**Wilsonville City Hall
Development Review Board Panel A**

Monday, September 11, 2017 - 6:30 P.M.

B. Resolution No. 342

Exhibit A1
Planning Division Staff Report
Hilton Garden Inn

TREE PRESERVATION LEGEND

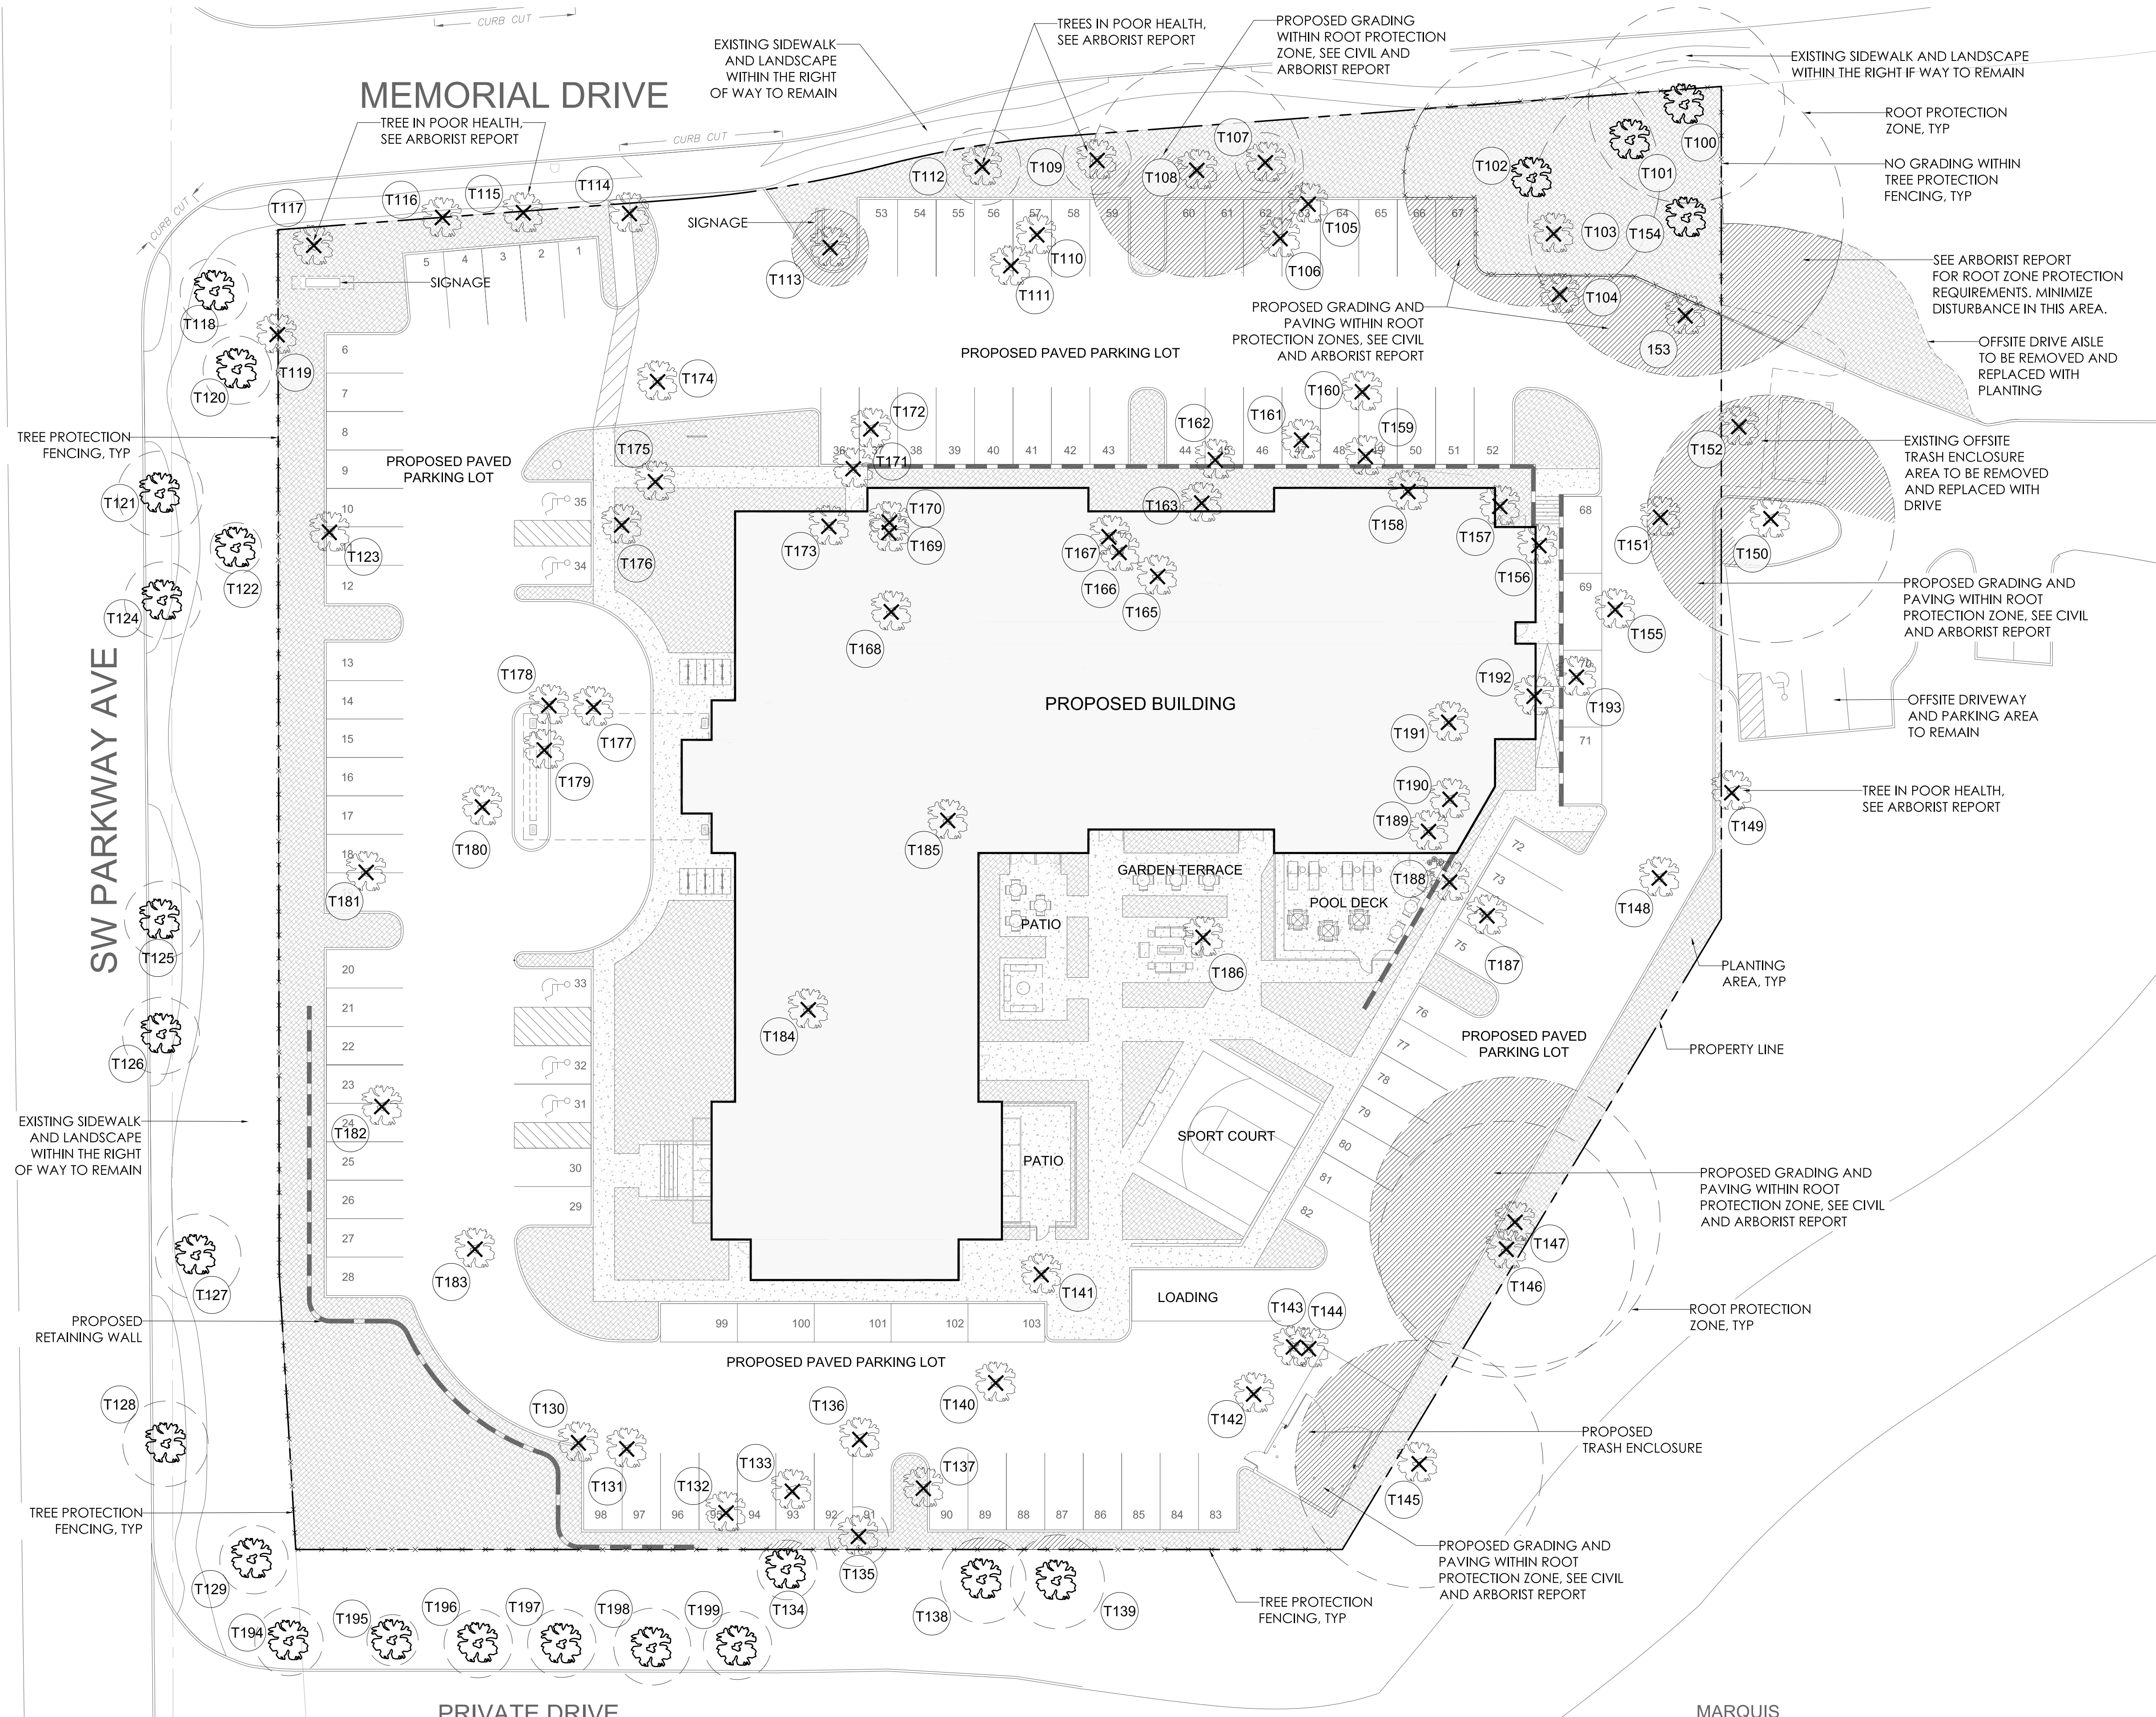
reducing the size of the proposed building and site layout. The tree plan on page L1.01 of Exhibit B3 shows five off-site trees proposed for removal, although as these are located on a separate property and the legal property owner has not authorized the removal of the aforementioned five trees, they are not being reviewed as part of this application.

Details of Finding: The applicant has submitted the necessary copies of a Tree Maintenance and Protection Plan. See the arborist's plan and report, Exhibit B2. Tree locations are shown on Sheet L1.01 of Exhibit B3, Applicant's Plan Set.

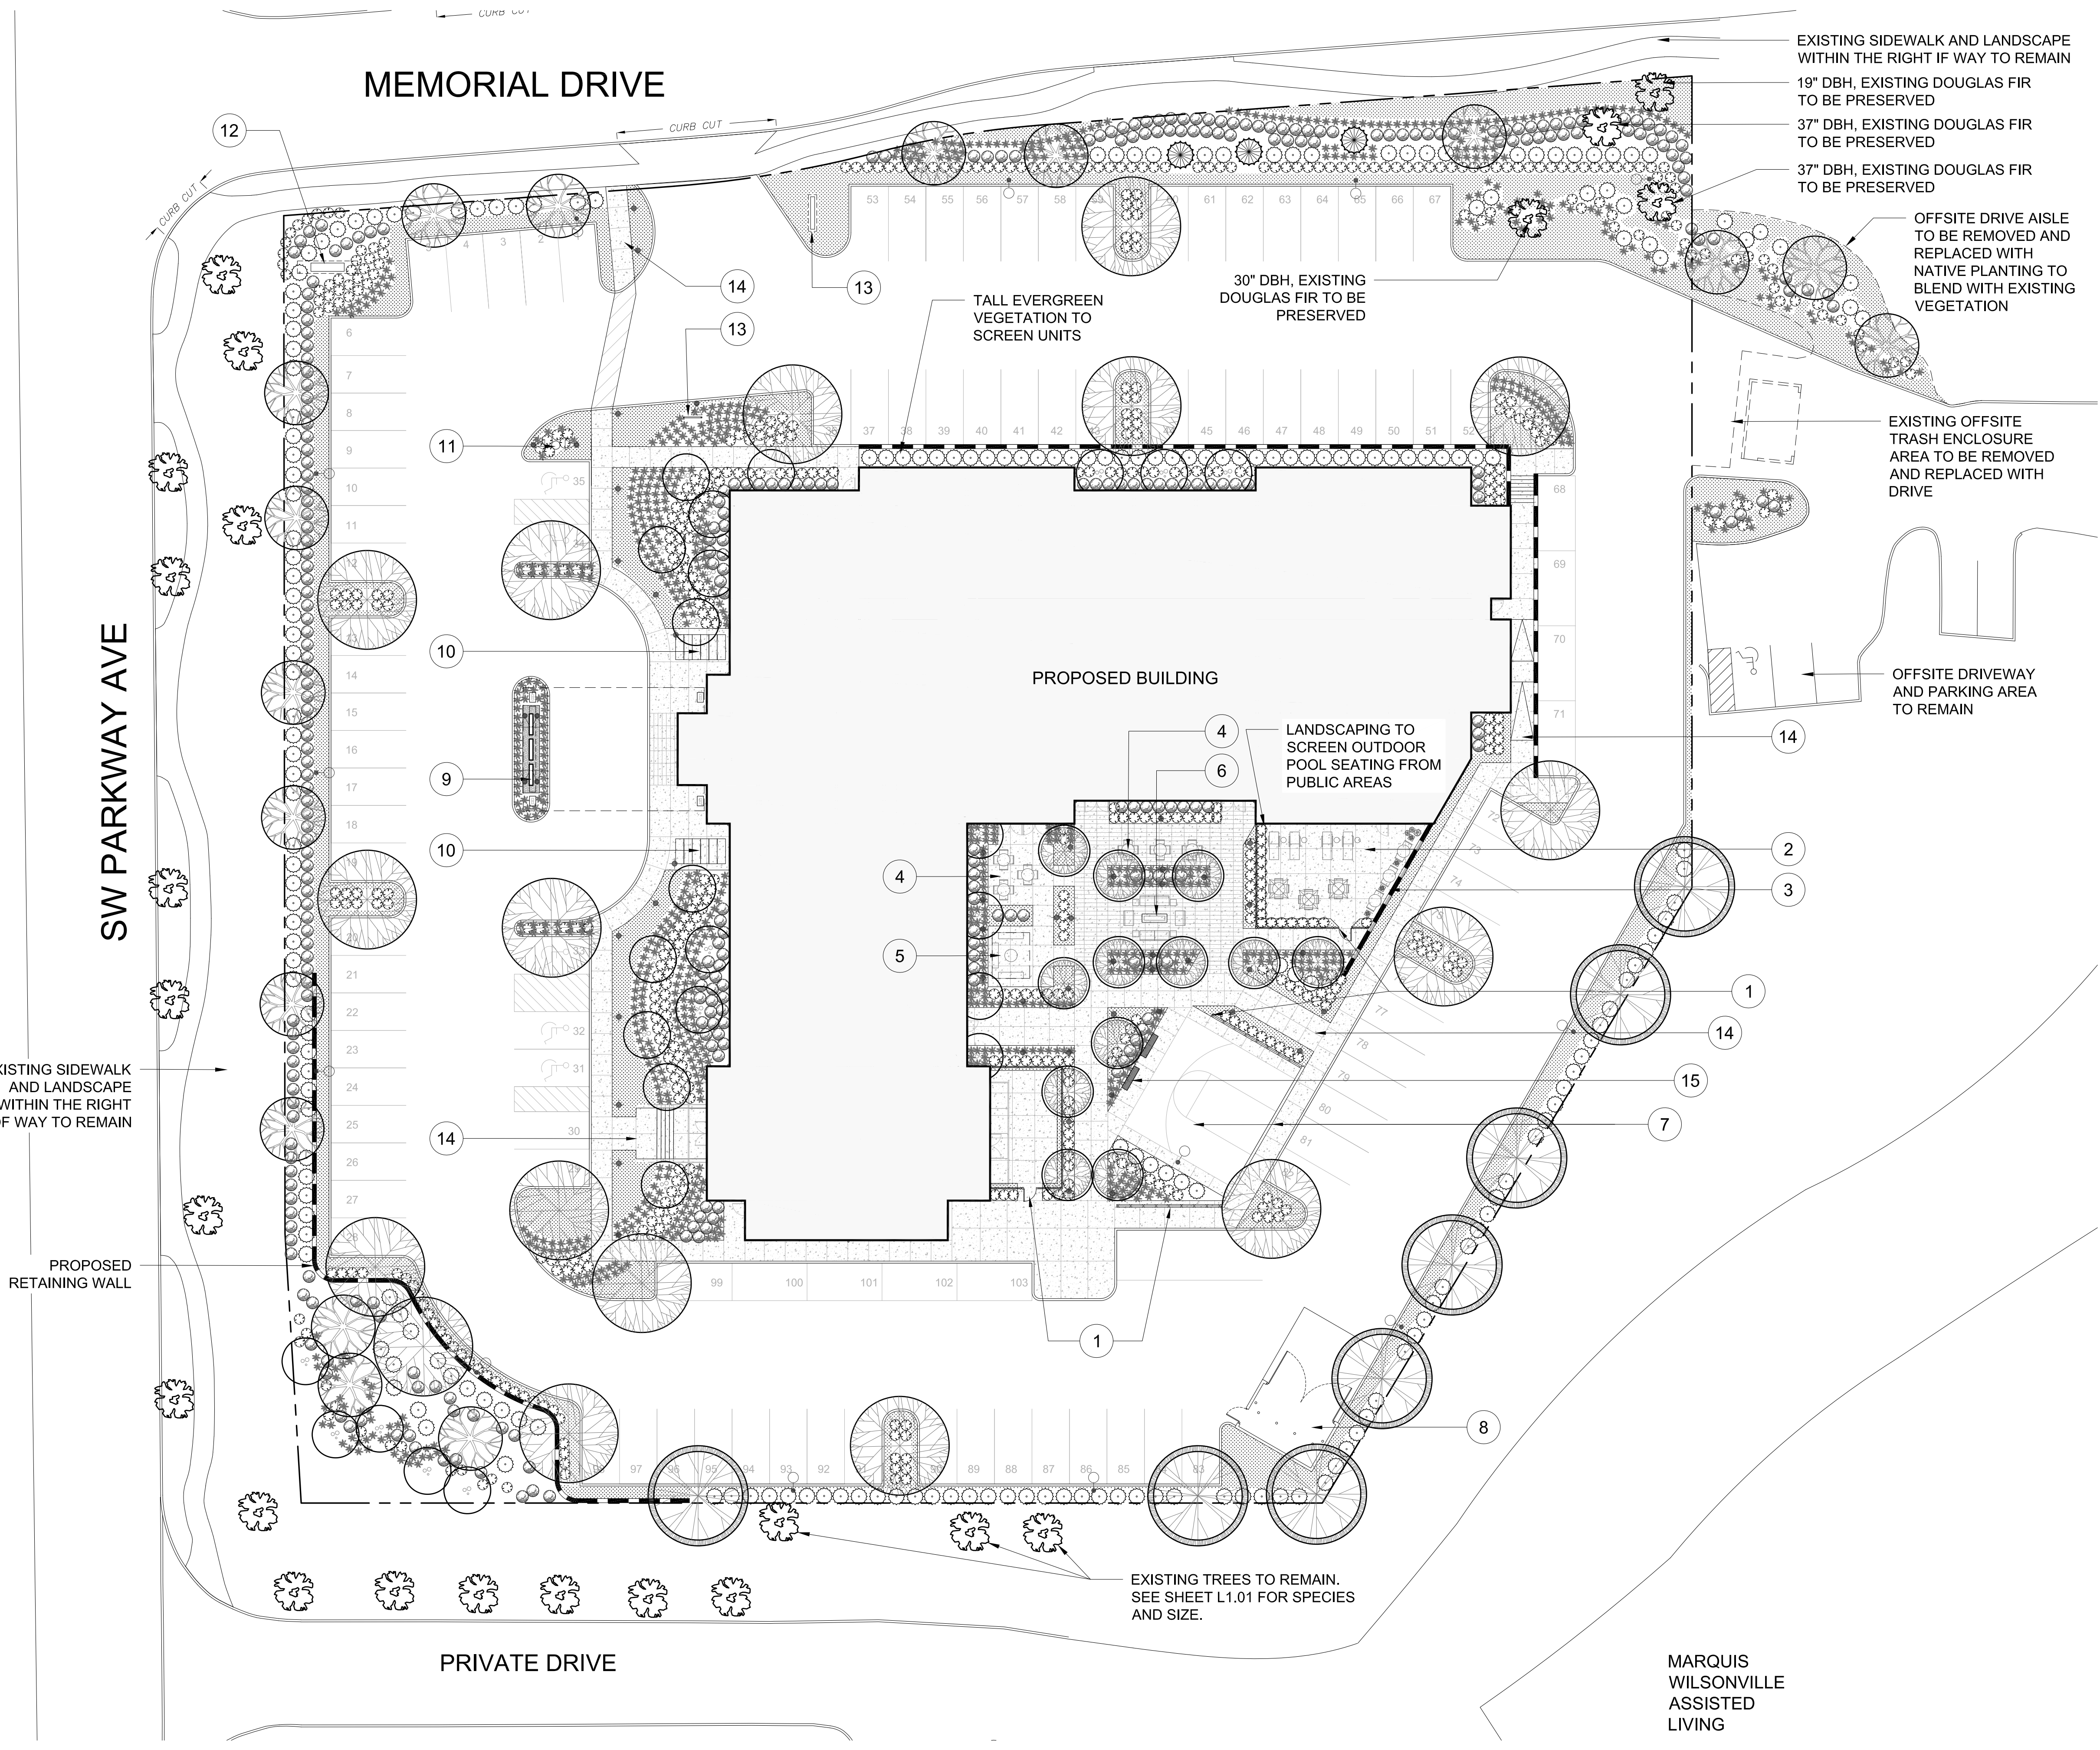
Response: As shown in their submitted landscape plans (sheet L2.01 of Exhibit B3) and described partially in their narrative, the applicant proposed an enhanced landscape meeting or exceeding City standards.

Response: Consistent with the proposed Stage II Final Plan for the site, applicant’s sheet L2.01 indicates landscaping will cover 22 percent of the site. Landscaping is proposed in a variety of different areas described in Finding A70. Planting areas are provided around the proposed building and surrounding parking areas. A wide variety of plants have been proposed to achieve a professional design. The design includes consideration of using native plants, including use of Vine Maple, Pacific Dogwood, Oregon Ash, Crimson Spire Oak, Forest Green Oak, and Douglas fir.

- The applicant's planting plan (sheet L2.01 of Exhibit B3 shows all trees as B&B (Balled and Burlapped)
- The applicant's planting plan lists tree sizes meeting requirements.
- A condition of approval will ensure the remaining criteria of this subsection are met.

Response: The applicant has provided sufficient information in their landscape plan (sheet L2.01) showing the proposed landscape design meets the standards of this subsection.

Division staff.
PDD 3.	The Applicant/Owner shall install the required fifty-seven (57) mitigation trees, as shown in the Applicant's sheet L2.01, per Section 4.620 WC.
PDD 4.	Replacement trees shall be state Department of Agriculture Nursery Grade No. 1 or better.
PDD 5.	The permit grantee or the grantee's successors-in-interest shall cause the replacement trees to be staked, fertilized and mulched, and shall guarantee the trees for two (2) years after the planting date. A "guaranteed" tree that dies or becomes diseased during the two (2) years after planting shall be replaced.
PDD 6.	Prior to site grading or other site work that could damage trees, the Applicant/Owner shall install six-foot-tall chain-link fencing around the drip line of preserved trees. The fencing shall comply with Wilsonville Public Works Standards Detail Drawing RD-1230. See Finding D14.
